Planning Ref: 2021/94208

OUTLINE APPLICATION FOR RE-DEVELOPMENT OF FORMER WASTEWATER TREATMENT WORKS, INCLUDING DEMOLITION OF EXISTING STRUCTURES TO PROVIDE EMPLOYMENT USES (USE CLASSES E(G)(II); E(G)(III); B2 AND B8). FORMER NORTH BIERLEY WASTEWATER TREATMENT WORKS, CLIFF HOLLINS LANE, OAKENSHAW, BD12 7ET

This letter provides response to the Environment Agency's consultee comments.

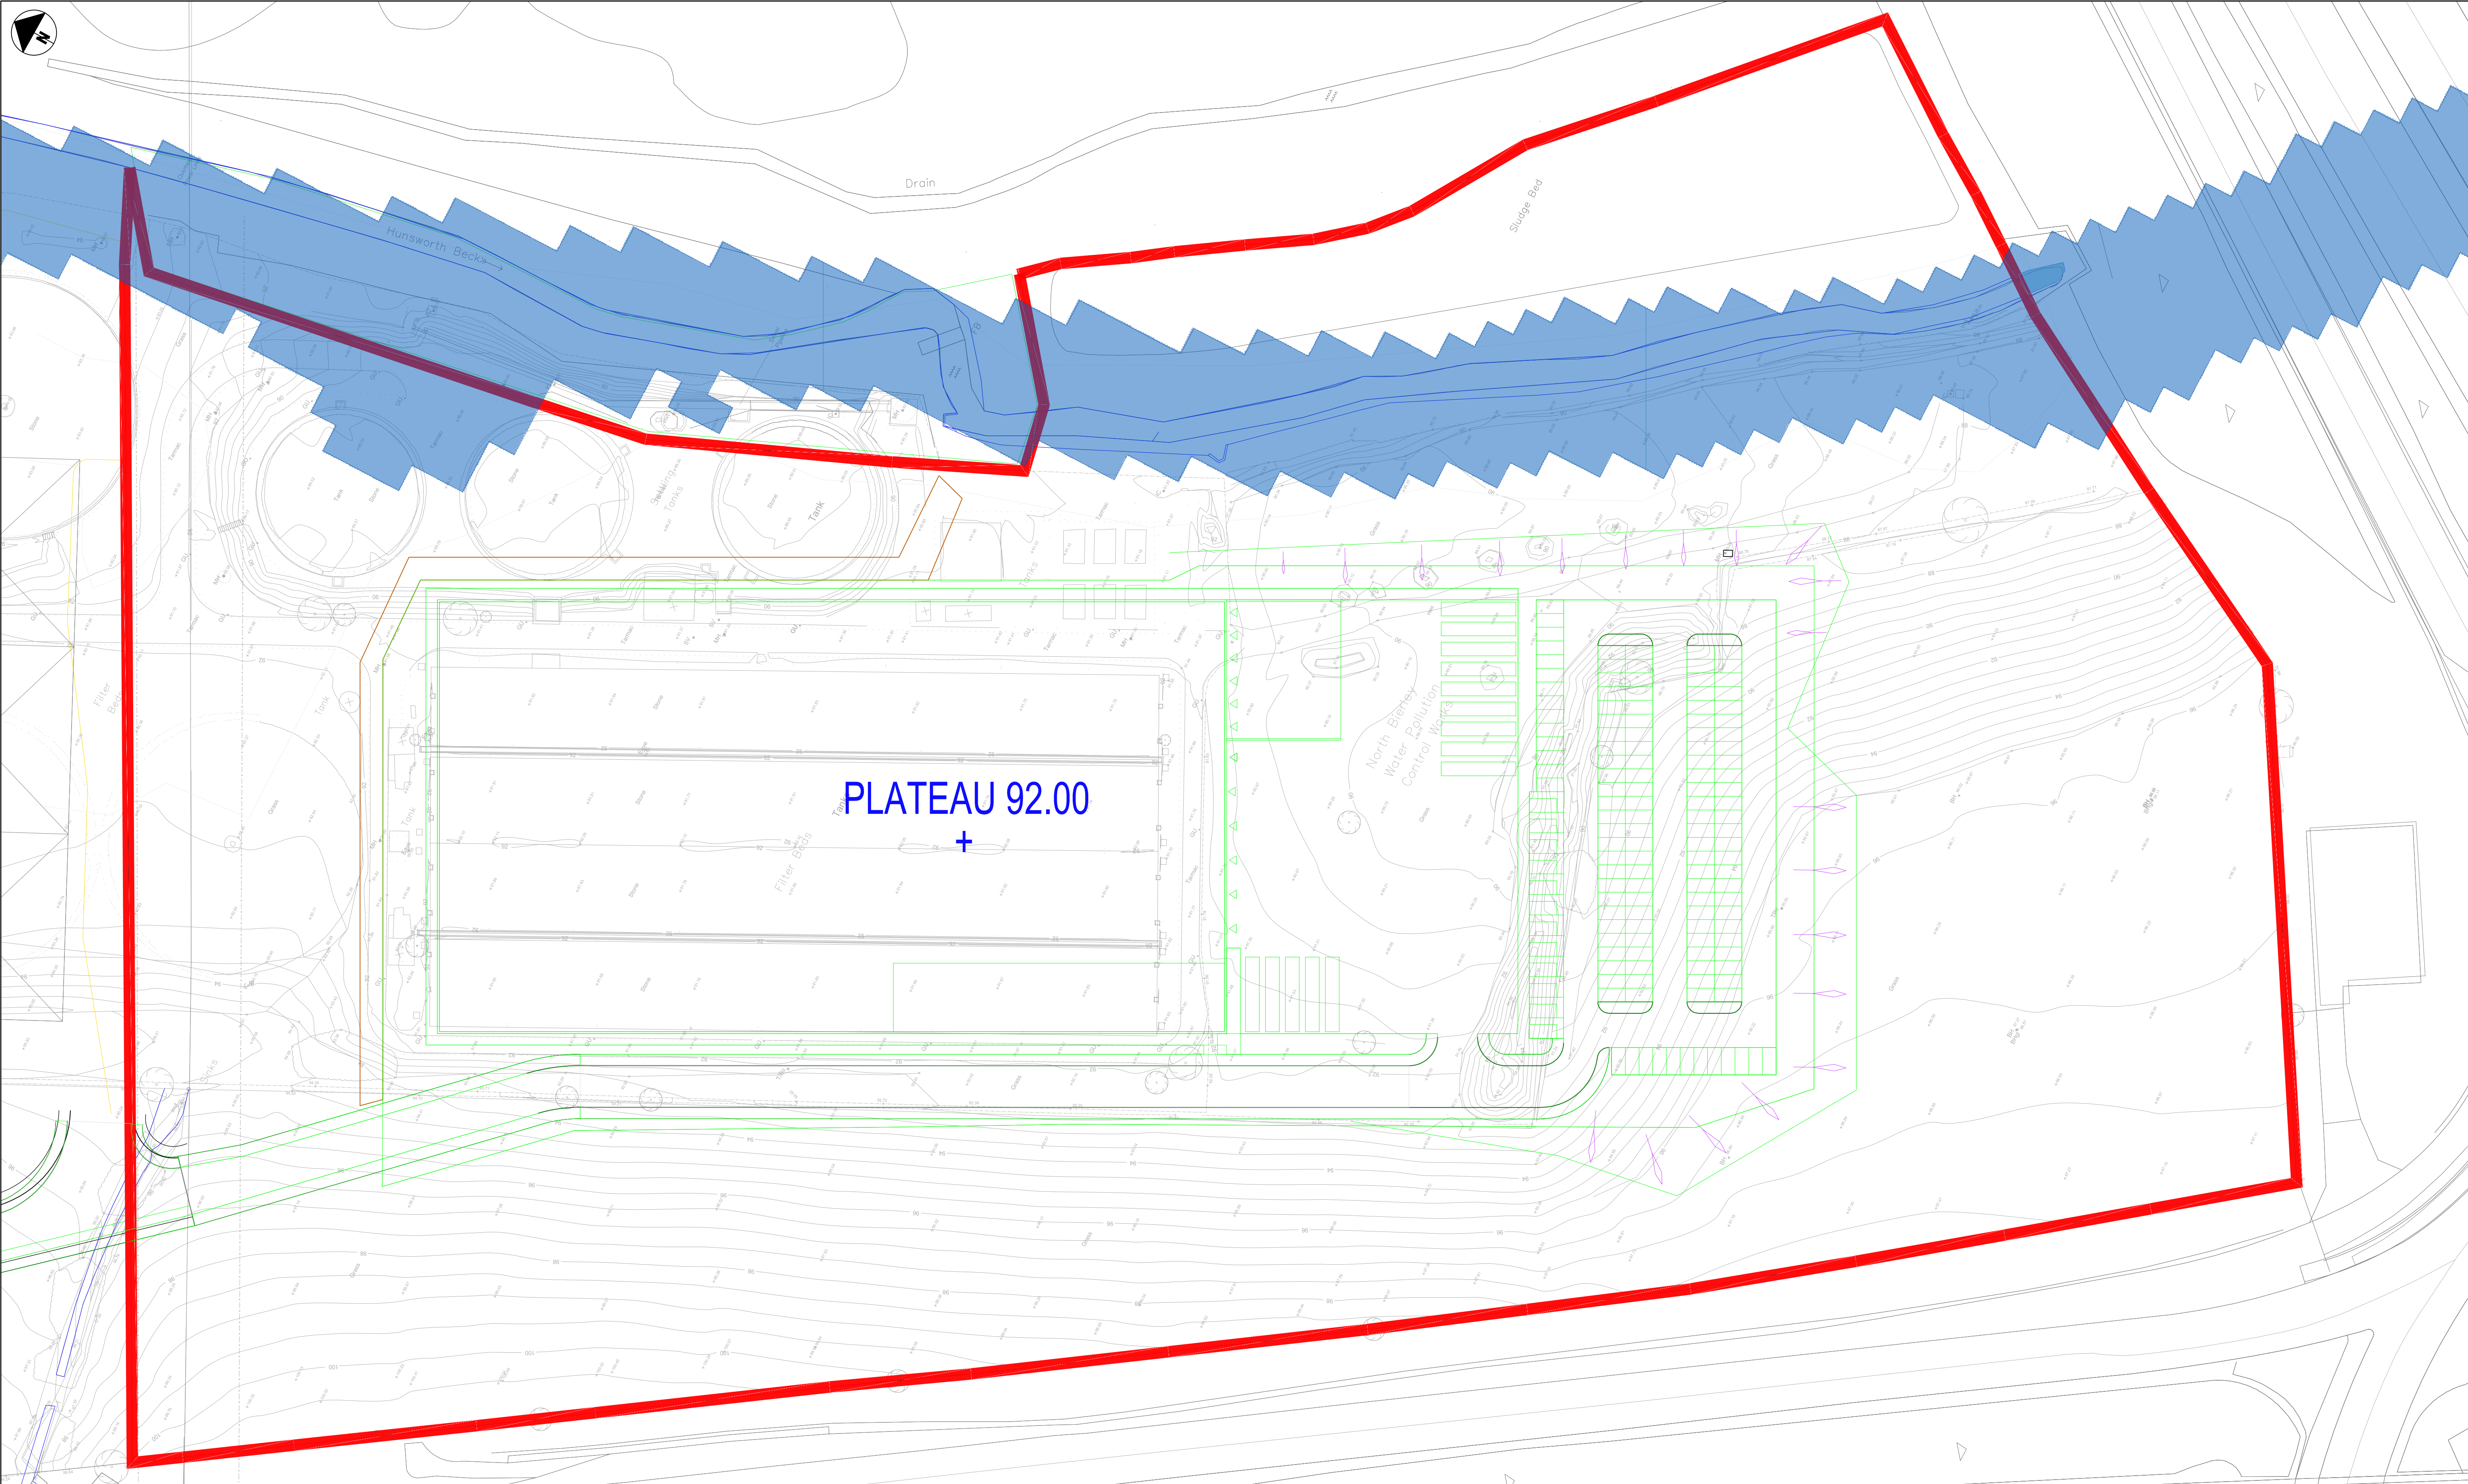
- 1) The majority of the site lies in Flood Zone 1, however, there is an area of Flood Zones 2 and 3 within the red line boundary and close to the development.**

On comparing the Flood Zone 3 extent against the topographical survey data, as is presented in 1926-CIV-XX-XX-GA-C-00001 (Appendix A), the site level at the point of the closest Flood Zone 3 (1% AEP) extent to the proposed development is circa 89.32mAOD (as presented in the image below). The proposed development plateau for the site is 92mAOD.

Attached to this letter is Civic Engineers' drawing 1926-CIV-XX-XX-GA-C-00001 (Appendix A) which presents the proposed development overlaid with the current flood zone 3 extents. This drawing confirms that the flood zone 3 extents protrude into the site's redline boundary, however the proposed development sits outside of the extents.

As above in item 2, the design level (which excludes climate change) is the point of the closest Flood Zone 3 (1%AEP) extent to the proposed development (circa 89.32mAOD). The proposed finished floor levels are to be set to the development plateau level (92.00mAOD) and therefore this is set higher than 600mm above the design flood level.

RFI/2021/221873 Node Point Map Centred on Your Site at Hunsworth Beck, BD12 7ES

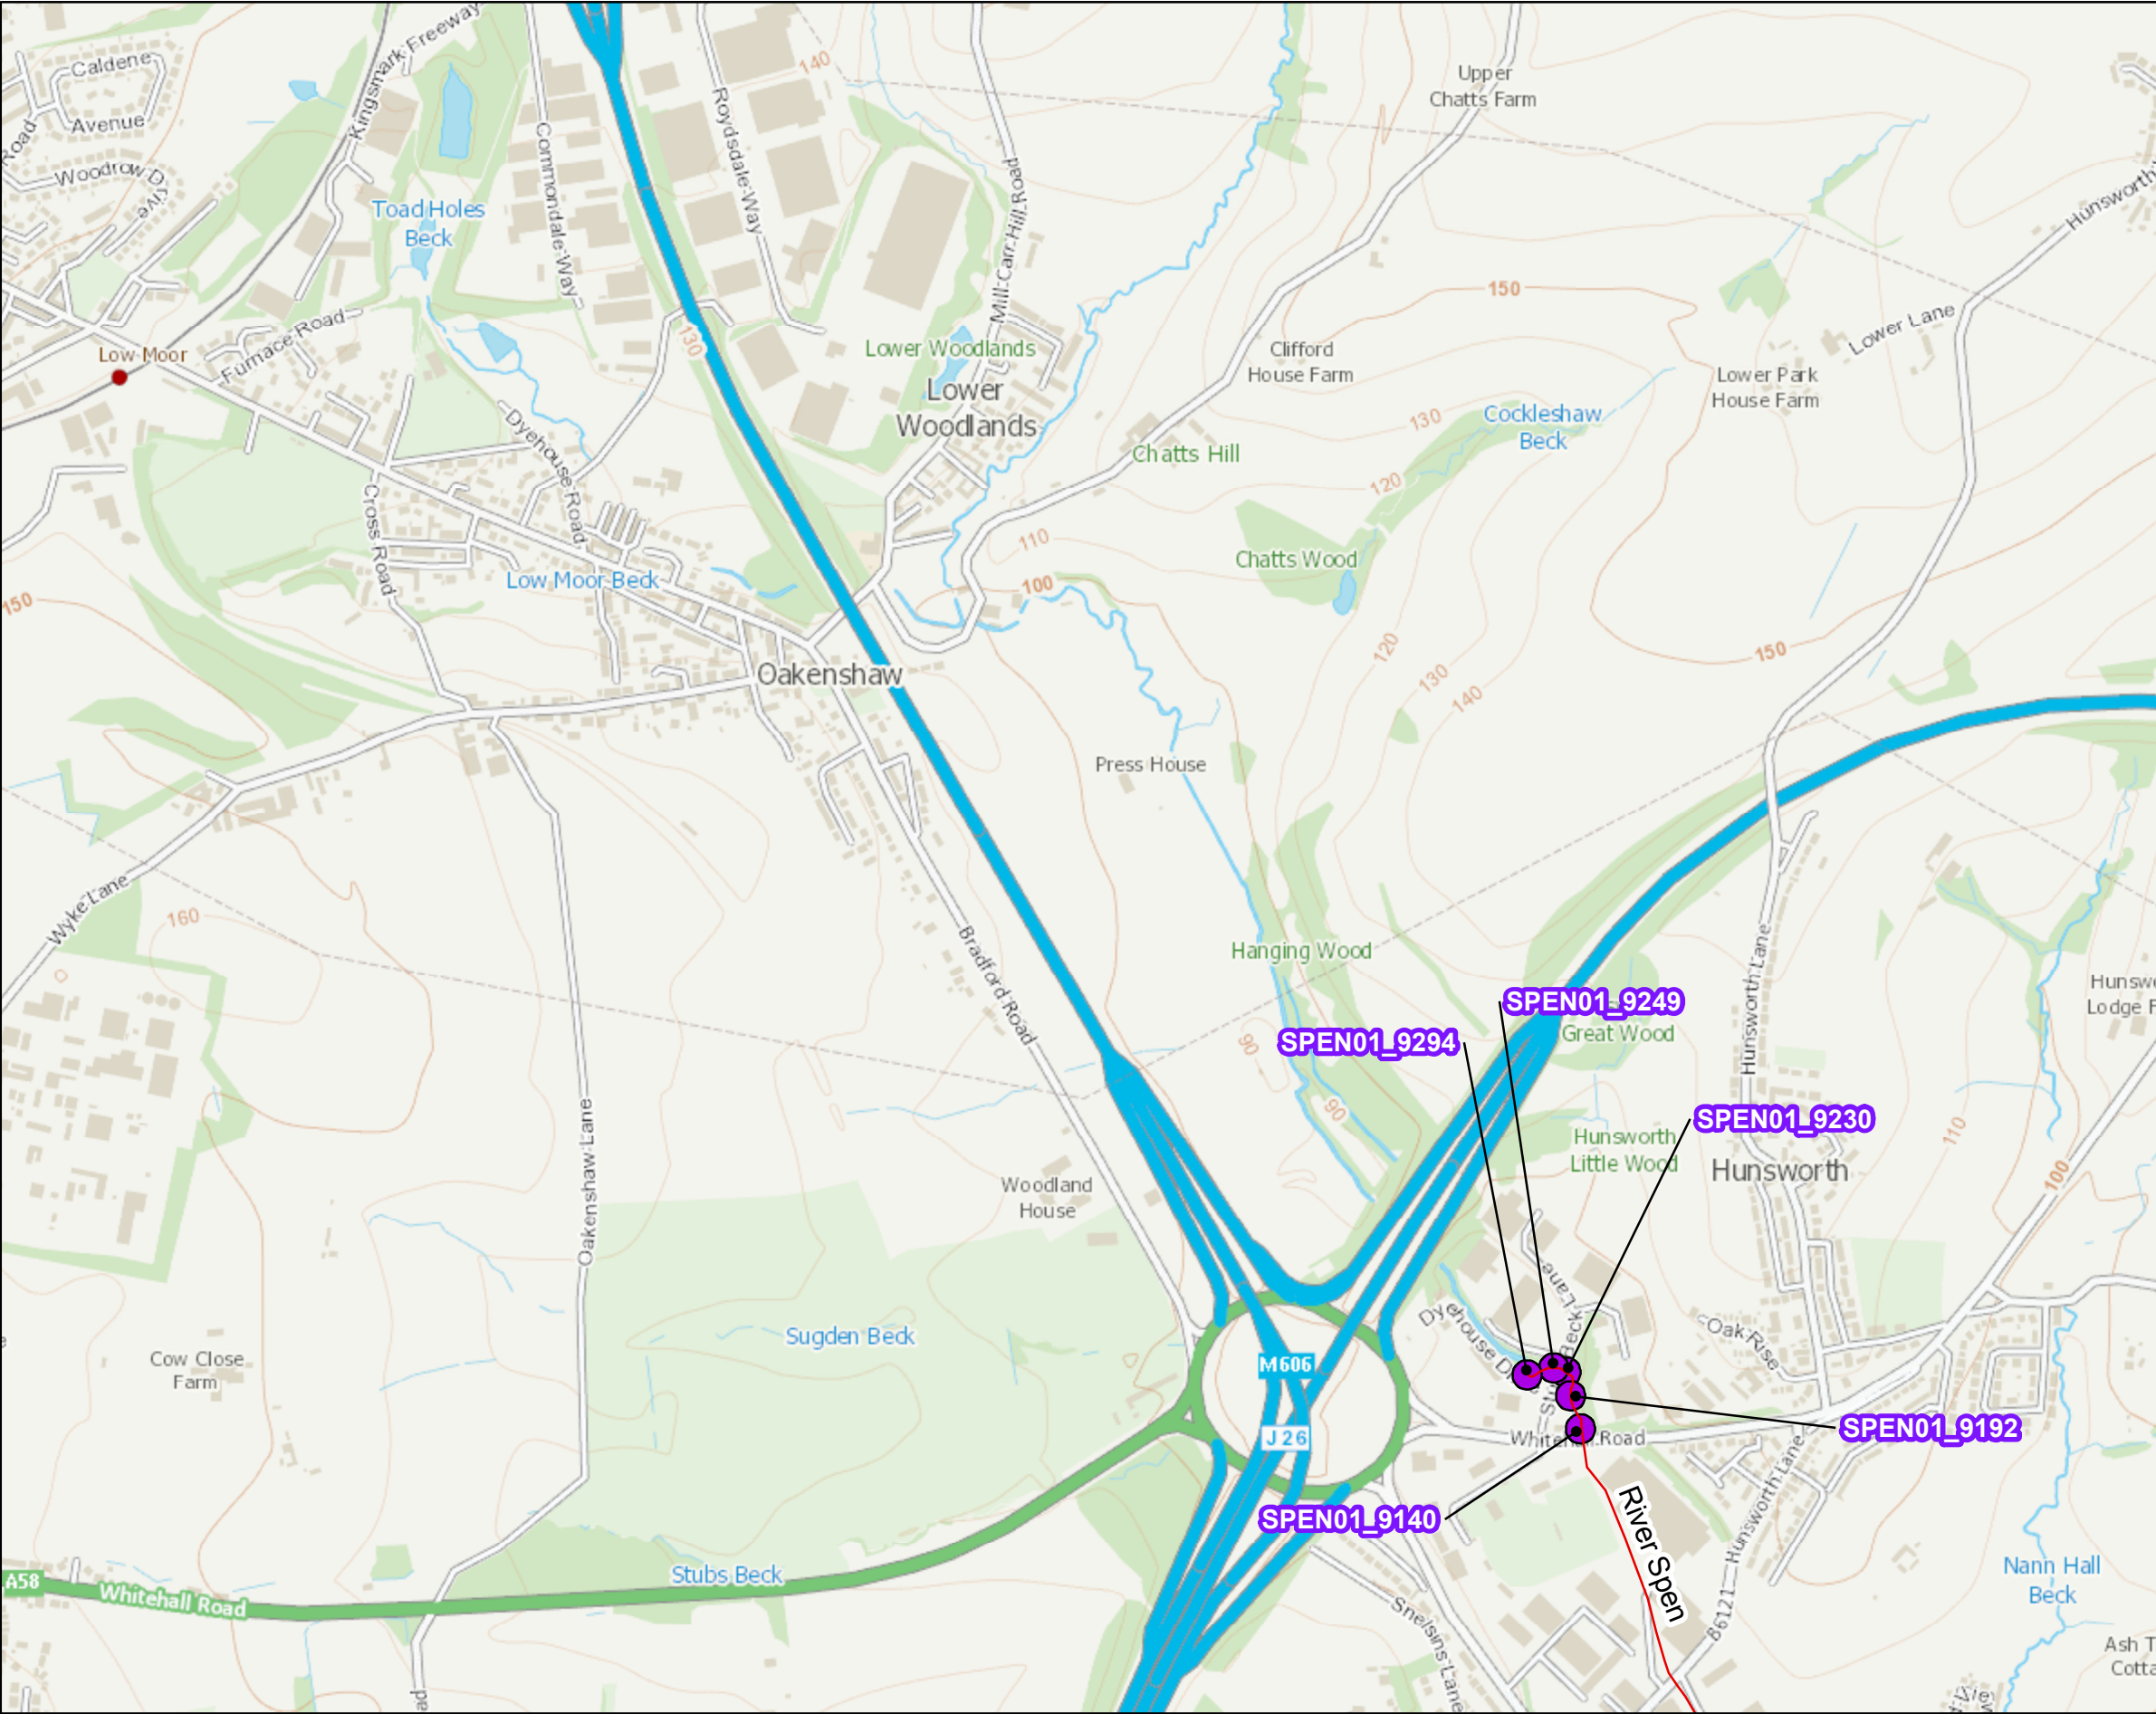
- 2) In particular, the FRA fails to take the future impacts of climate change on flood risk from rivers into account for the lifetime of the development.**

The model node locations on the River Spen are located downstream of the M62 (as is presented in the image below) and the most upstream is node 'SPEN01_9294' which has a 1% AEP + 20% CC flood level of 85.471mAOD. Since this node is too far downstream of the development (which has a lowest site level point of approximately 87.87mAOD), it is clear that the model outputs nodes provided cannot be used to inform the development.

During the request on the 6th January, the EA were asked to confirm that there weren't any model nodes adjacent to the site and that the nodes shown in 'Node Point Map 221873.pdf' are the closest to the site. In response, the EA stated "*The watercourse adjacent to your site does not have any detailed modelling therefore we cannot provide any node points and/or data*". Therefore, the only data available to undertake the assessment is the flood zone extents.
